addendum

No. 02

Project: Missouri Center for Oral
Surgery & Implants

Project No: 024-2117

UTILITY PLAN
C500

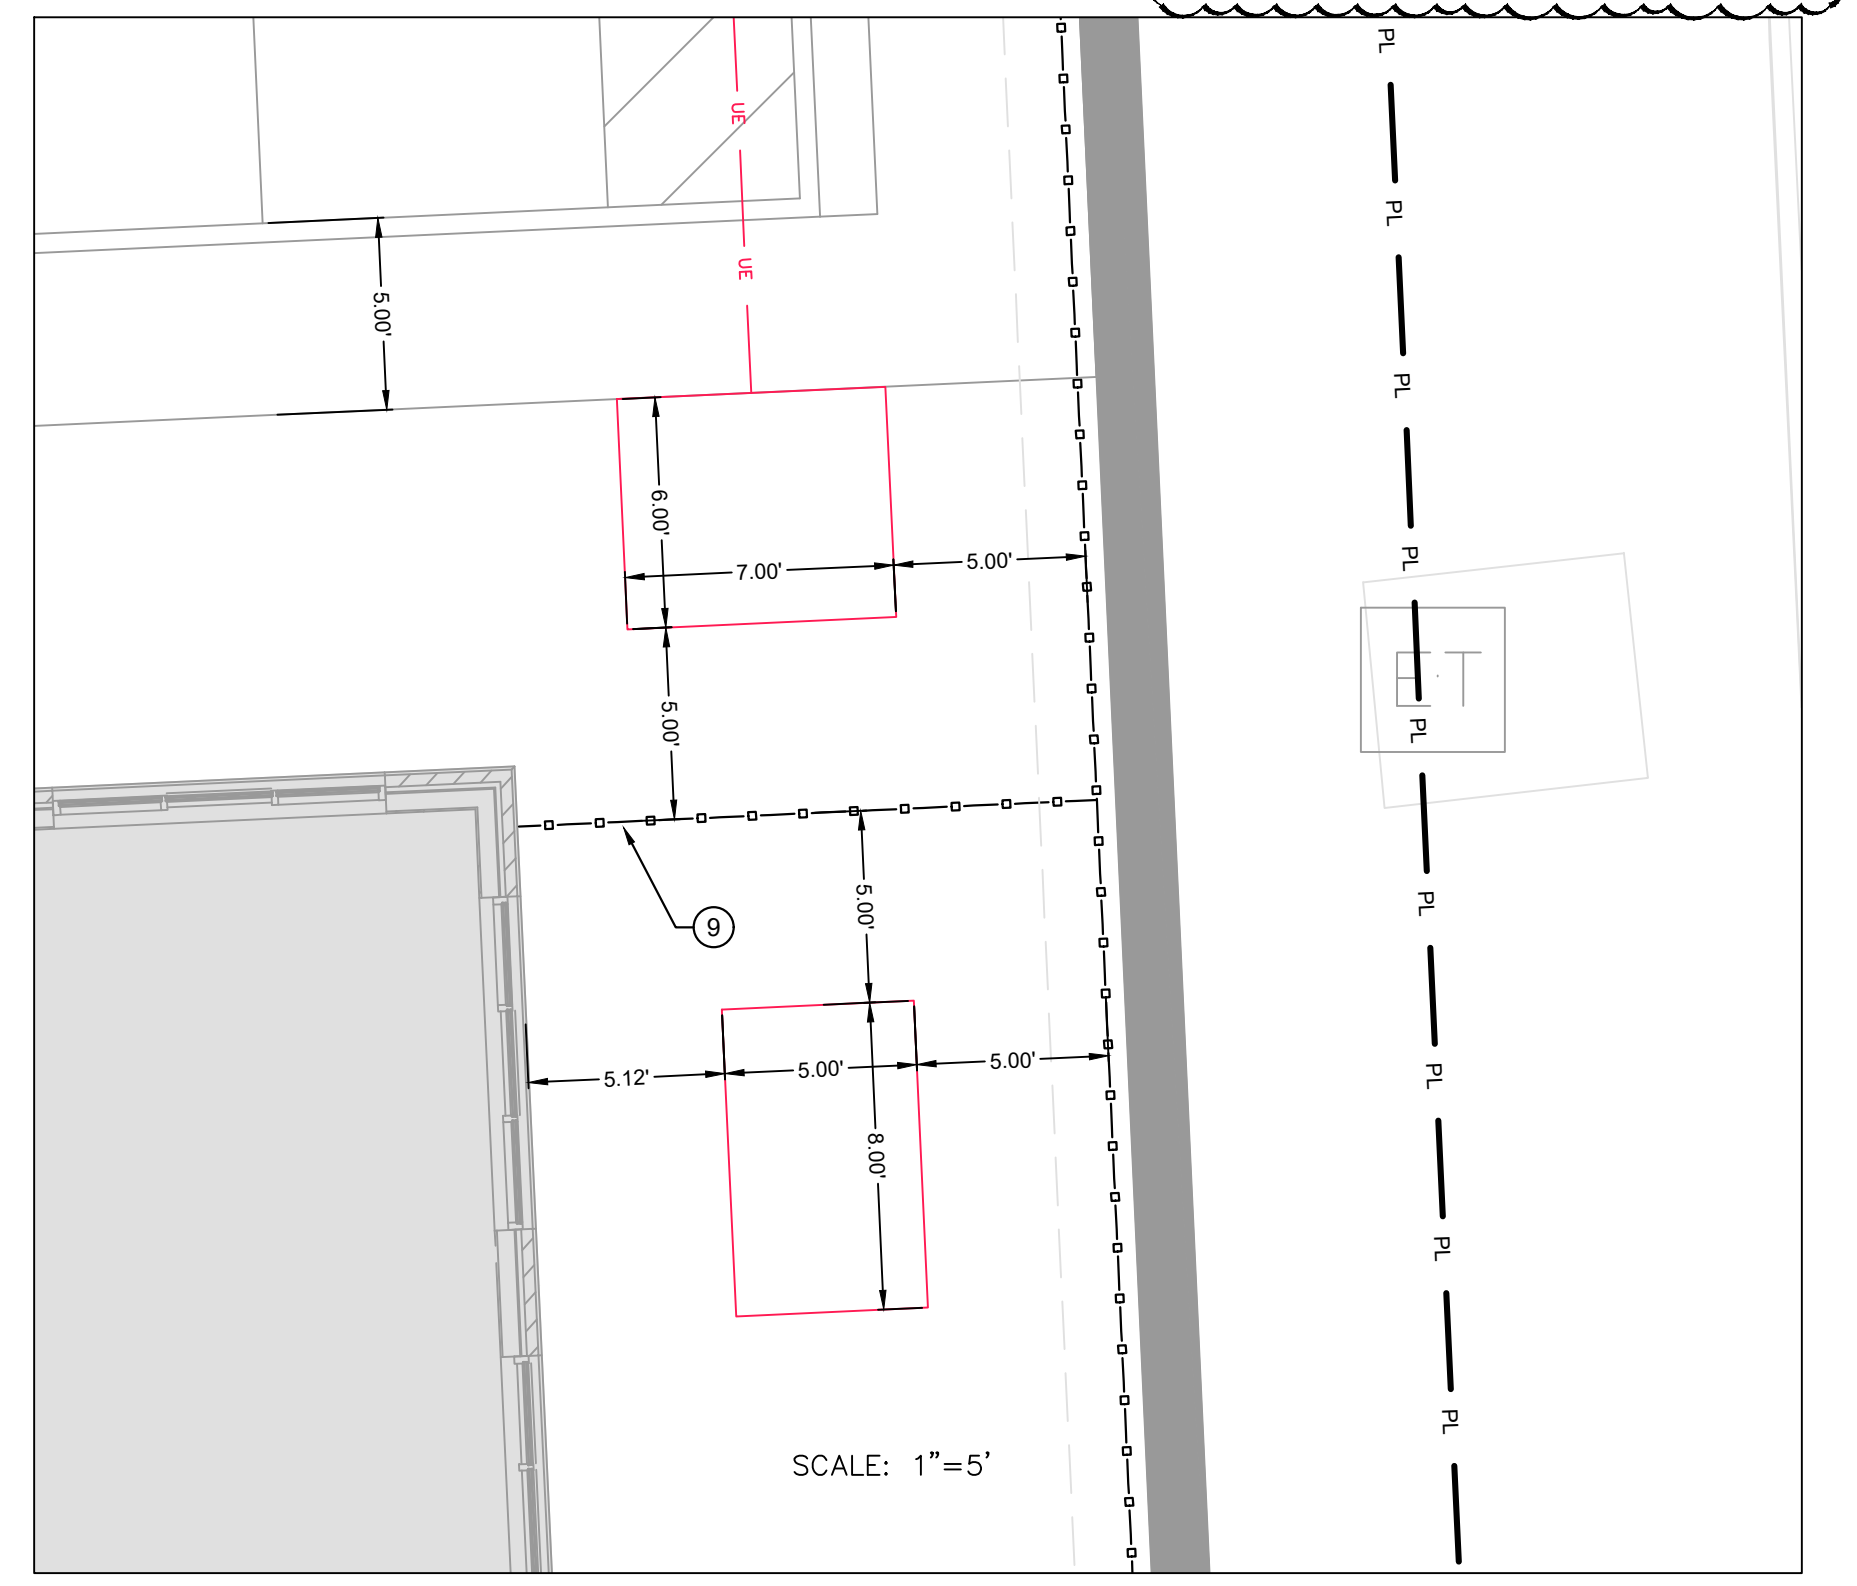
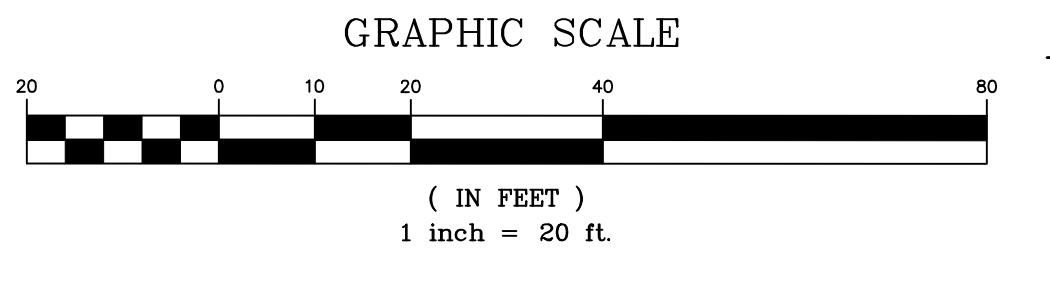
- 2. Question:** Fireline RFI- What size is the proposed fire line? The City of Wentzville requires a detector check and the civil engineer does not show one on the utility plan.

Answer: Please see attached revised plans.

1. C500
2. C900
